A66 Northern Trans-Pennine project

Proposed changes consultation

January/February 2023

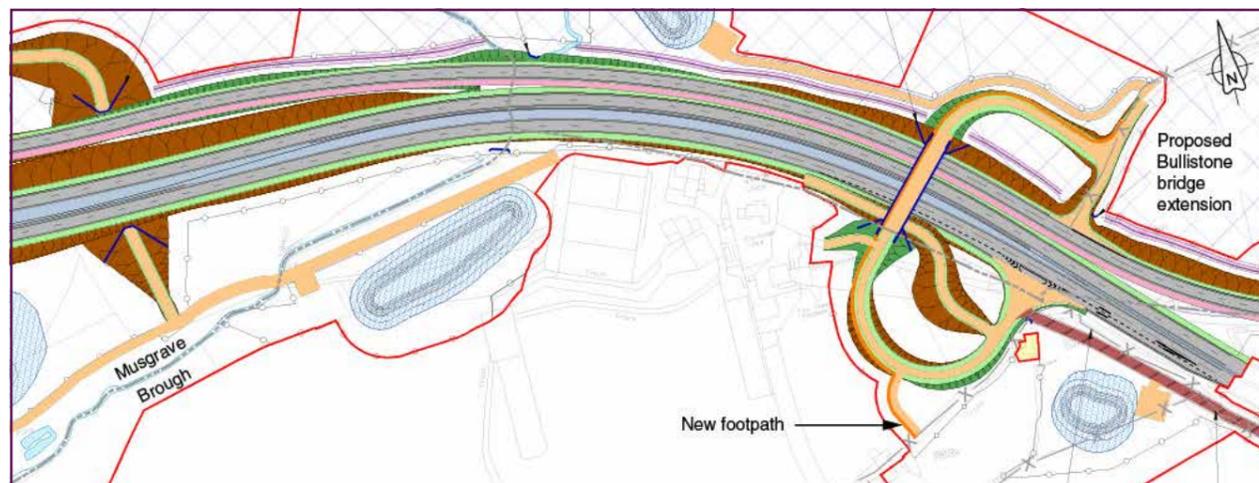
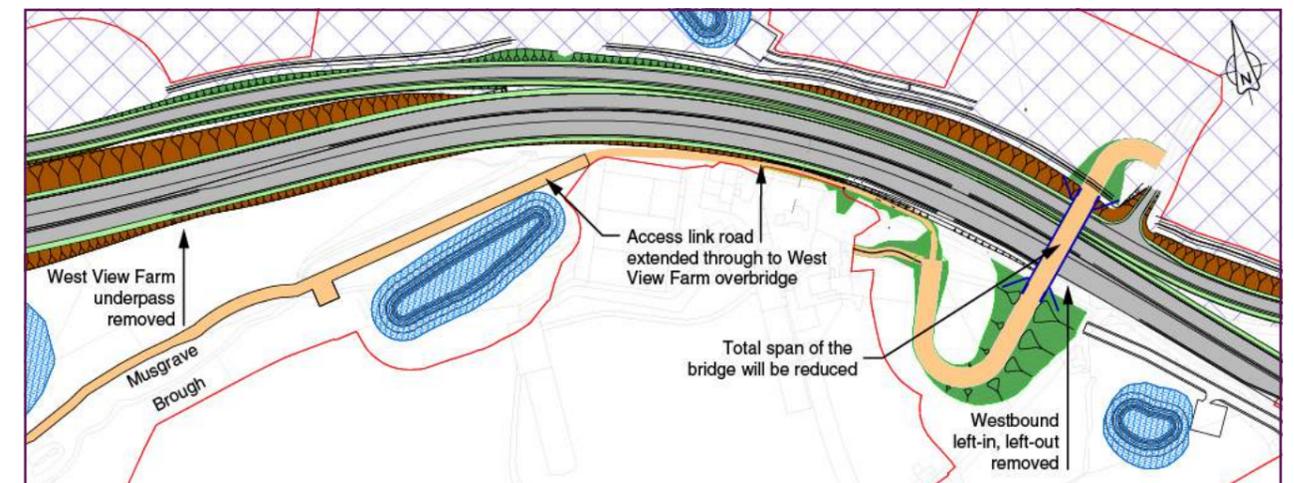
This change has been requested by the landowner and residents of adjoining properties who raised concerns about the proximity of the structure and unauthorised access to the farm and properties by people wanting access to Brough from the A66. It also addresses the landowner's concerns about security, the amount of land required and the proximity of the bridge to residential buildings.

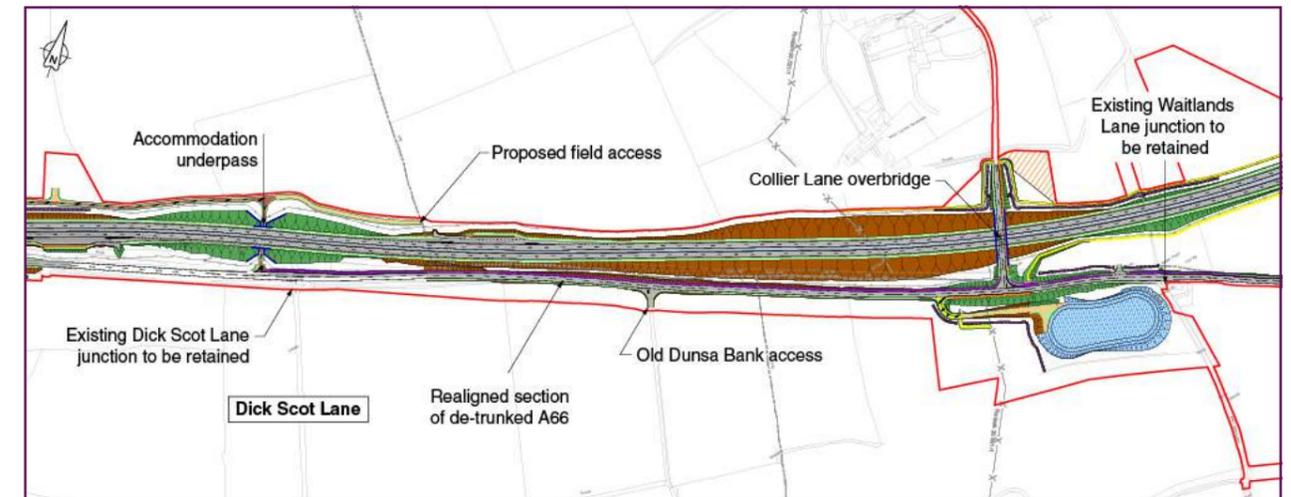
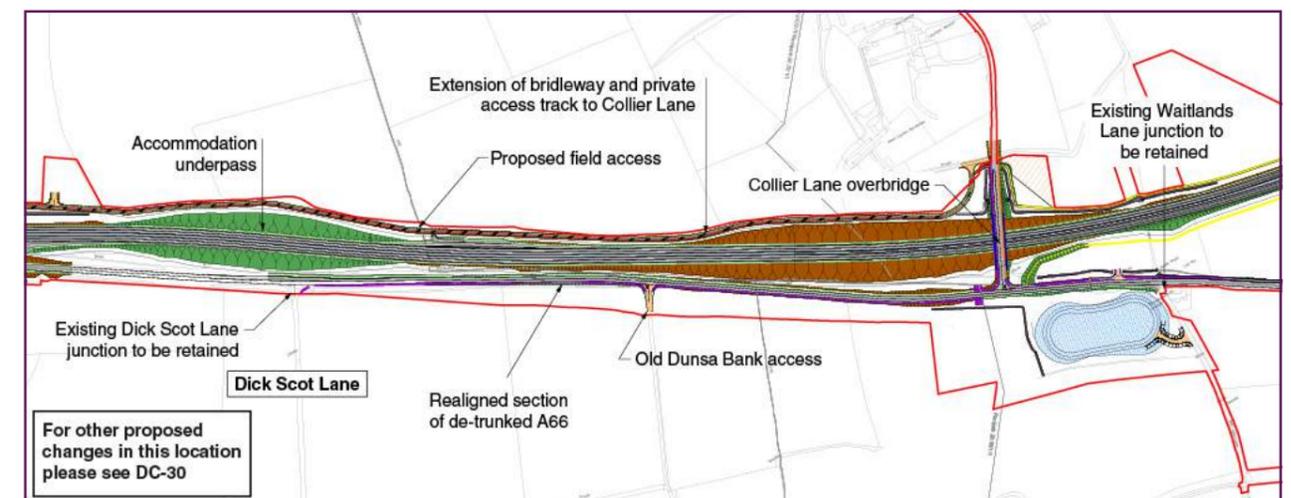
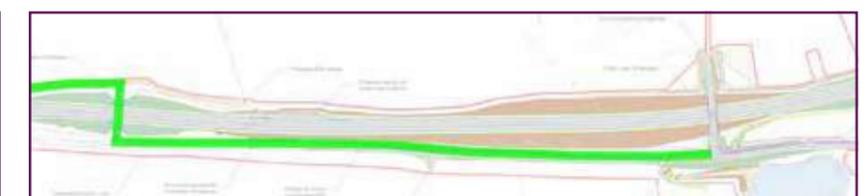
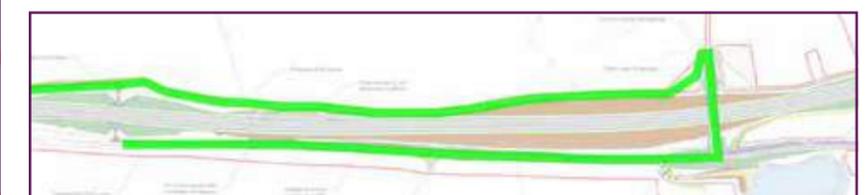
This change will remove the need for a temporary diversion road during the construction of the project. If we reduce the size of the cutting, this will reduce the earthworks, helping in turn to reduce construction traffic and shorten the build programme.

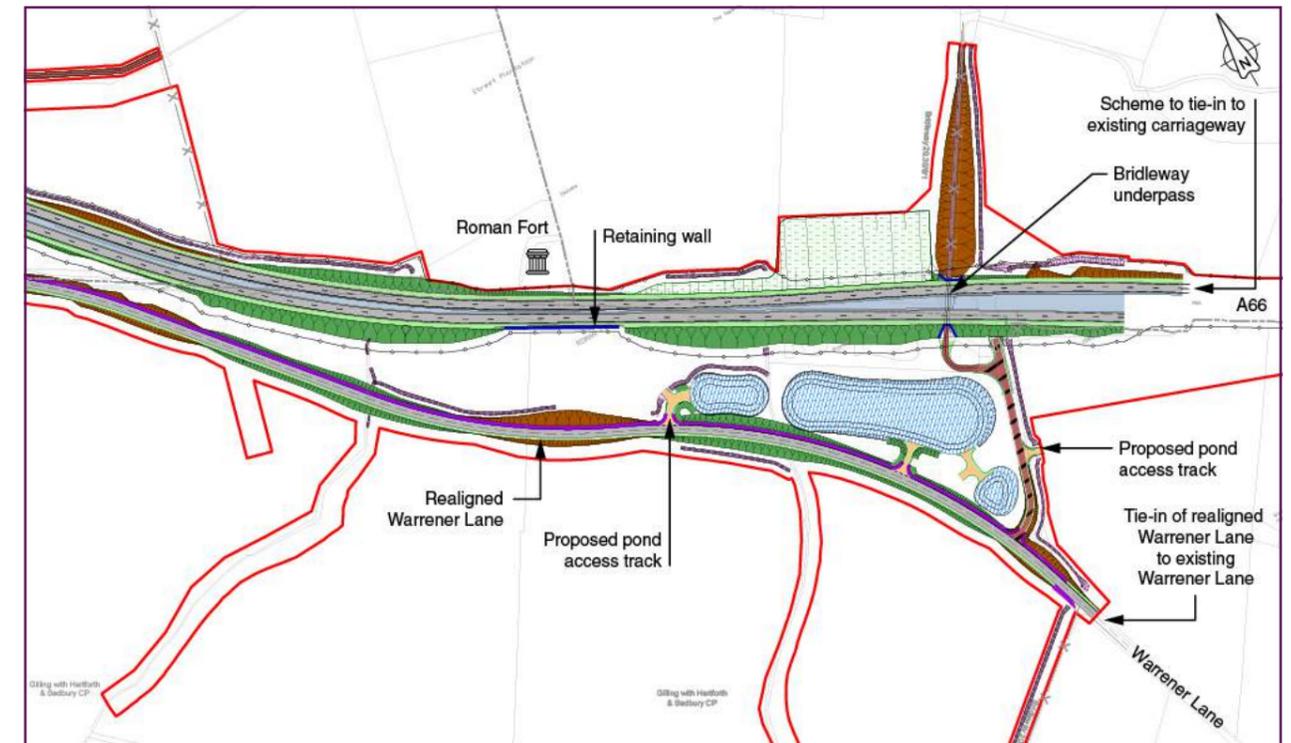
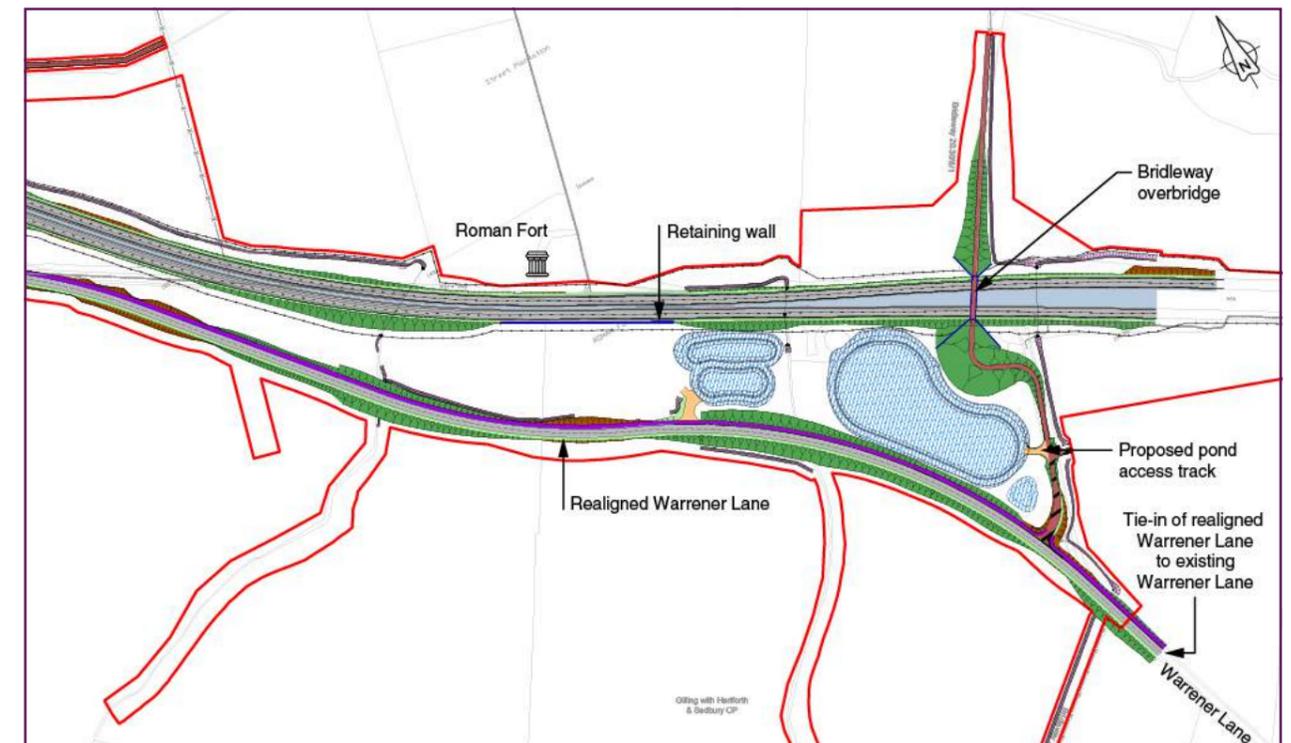
The drainage network will need to be modified as a result of lowering the mainline. Early detailed design work suggests this will result in an increase in the size and number of drainage ponds at the eastern end of the scheme. Further detailed design work is required to develop and optimise the number and size of ponds.

DCO-28 – Realignment of local access road to be closer to new dual carriageway east of Bowes

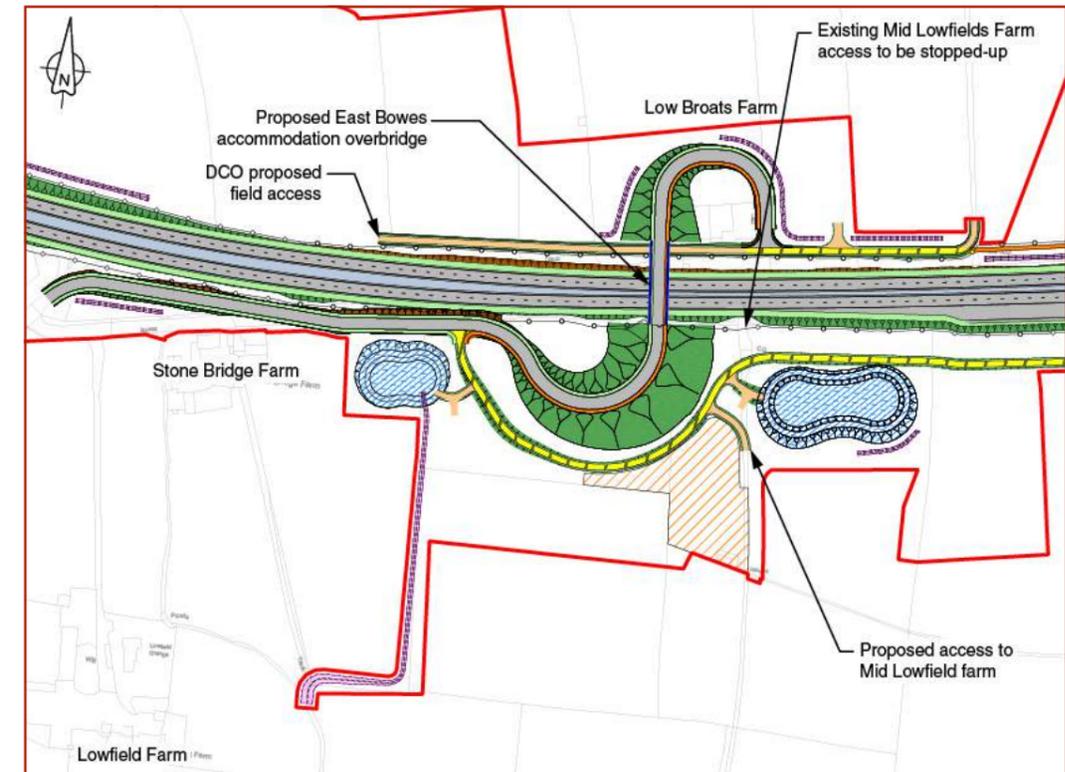
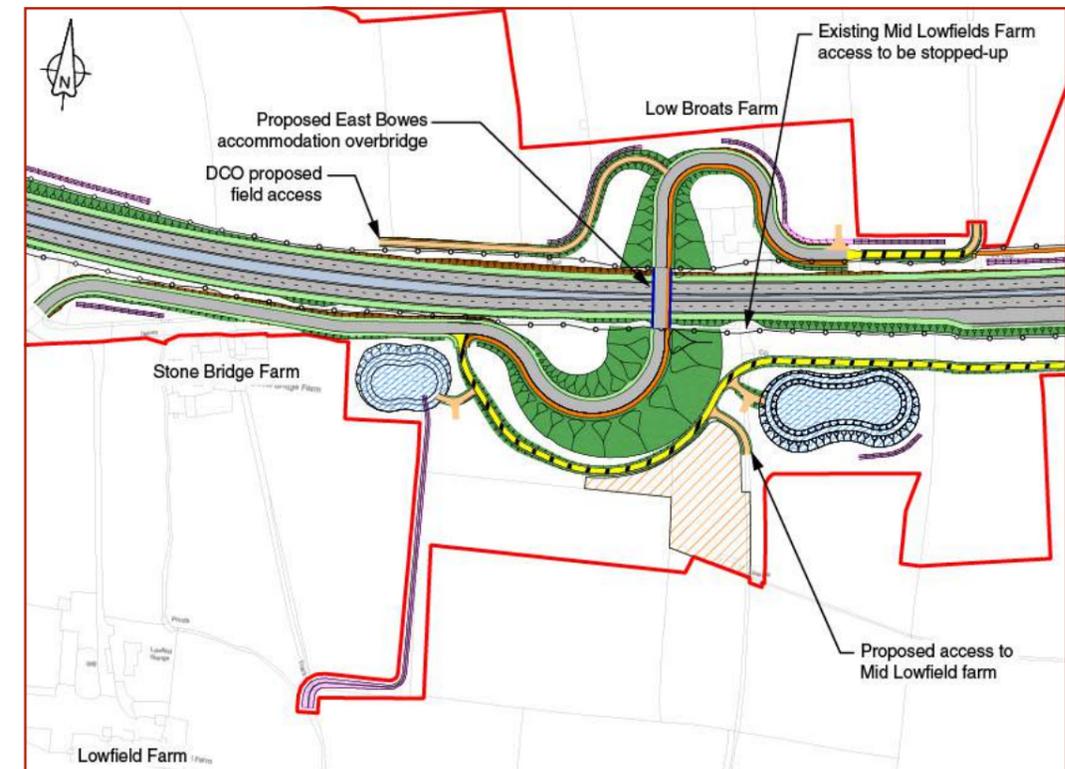
East of Bowes our DCO design includes separation between the dual carriageway and a private access track to help us build the road. Early detailed design has determined that this provision is no longer required. An increase in the lateral LoDs will enable the overbridge design to be simplified and moved closer to the dual carriageway.
